NO: PC-365	**PRODUCT:** NJ
DATE: October 2018	**TYPE:** Modification Notice

Notice of Hardware Revisions for the Sysmac NJ101, NJ301 and NJ501-Reissue-Change to Release Dates and Firmware Matrix

NJ101 and NJ301 Series Revisions

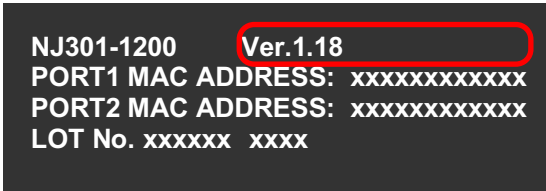
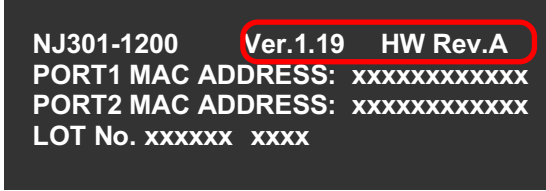
NJ101 and NJ301 Series. Due to component life issues, new hardware versions will be released. This release will also increase performance.

Changes of Instruction execution times
    Instruction execution times are improved with the change as below.
    There will be no change in user controller program operation

Instruction execution times
    ・NJ301 Series
LD instruction: 2.0ns (3.0ns or less)
  Math instructions (for long real data): 42ns or more

・NJ101 Series
LD instruction: 3.3ns (5.0ns or less)
  Math instructions (for long real data): 70ns or more
	・NJ301 Series
	LD instruction: 1.6ns (2.5ns or less)
	  Math instructions (for long real data): 34ns or more

・NJ101 Series
	LD instruction: 3.0ns (4.5ns or less)
	  Math instructions (for long real data): 62ns or more

Current hardware platform	New hardware platform
Changes of display specifications The display specifications of hardware revision will be changed as below.

Change in display of unit version on the label.
Add display of hardware revision on the label.
